STAFF REPORT

SUBJECT: FP-2025-0011
Southridge South No. 2

LOCATION: 2347 W. Overland Rd., in the north 1/2
of Section 23, T.3N., R.1W.

L1.00

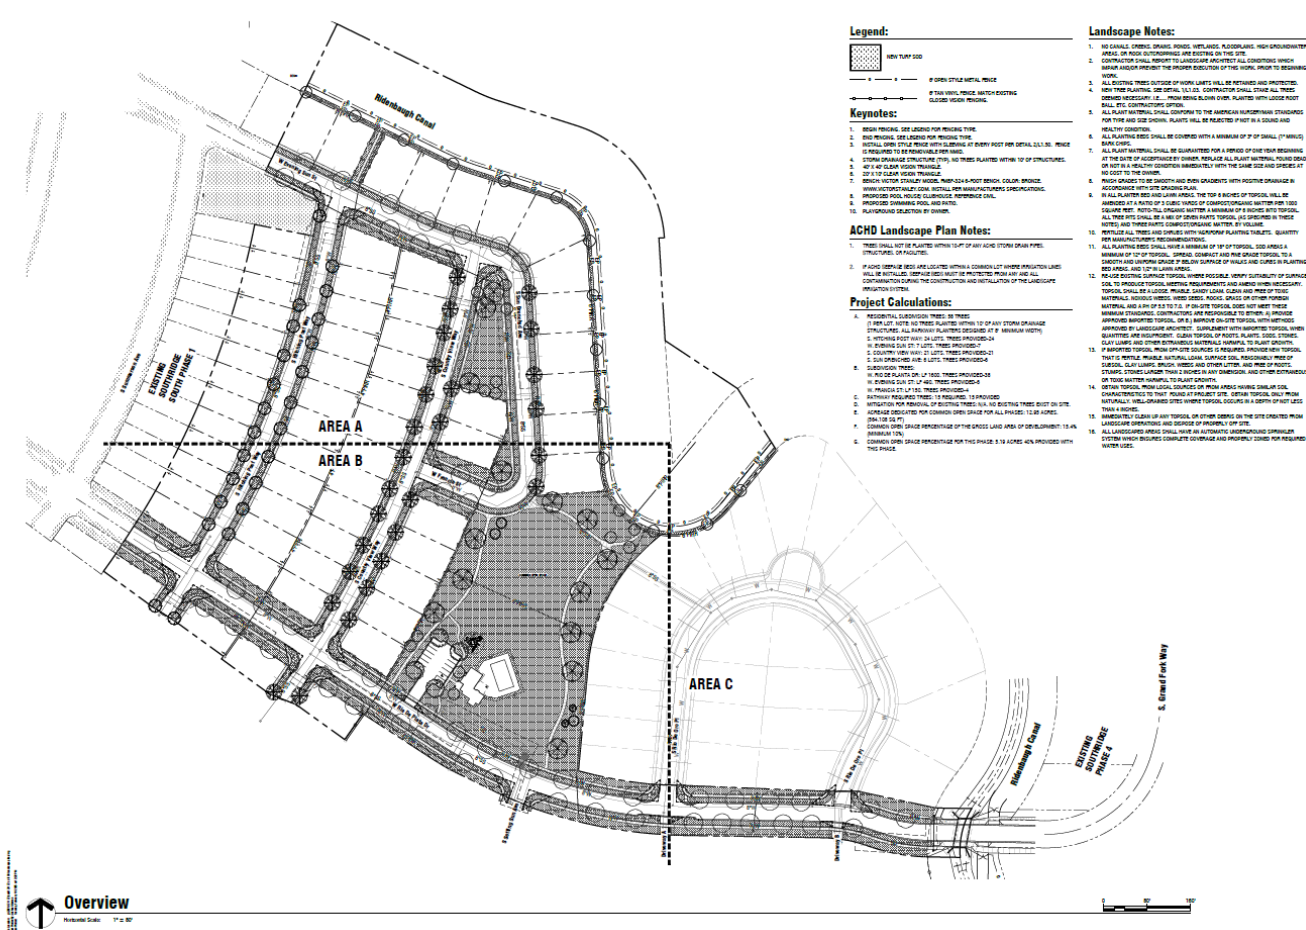
5. The landscape plan shown in Section V.C, prepared by The Land Group, dated 2/18/25, shall be revised as follows:
 - a. Depict landscaping along the pathway on Lot 42, Block 1 in accord with the standards listed in UDC [11-3B-12C](#), which requires a *mix* of trees (minimum of 1 per 100 linear feet of pathway), shrubs, lawn, and/or other vegetative groundcover per preliminary plat condition #4b.

- b. Depict landscaping in common open space areas in accord with UDC 11-3G-5B.3, which requires a *variety* of trees, shrubs, lawn or other vegetative groundcover.

- c. Correct Project Calculations table as follows:
 - i. Residential Subdivision/Subdivision Trees – a minimum of one tree is required per 35 linear feet of parkway as set forth in UDC [11-3B-7C](#), excluding 26 feet for curb cuts to each residential lot – the requirement is *not* one per lot as stated; revise accordingly.

- ii. Pathway Required Trees: Include linear feet of pathway on Lot 42, Block 1 (a minimum of one tree is required per 100 linear feet).

- iii. Include the required vs. provided number of trees in common open space areas that demonstrates compliance with UDC 11-3G-5B.3 (a minimum of one tree per 5,000 square feet is required).

A copy of the revised landscape plan shall be submitted with the final plat signature application.
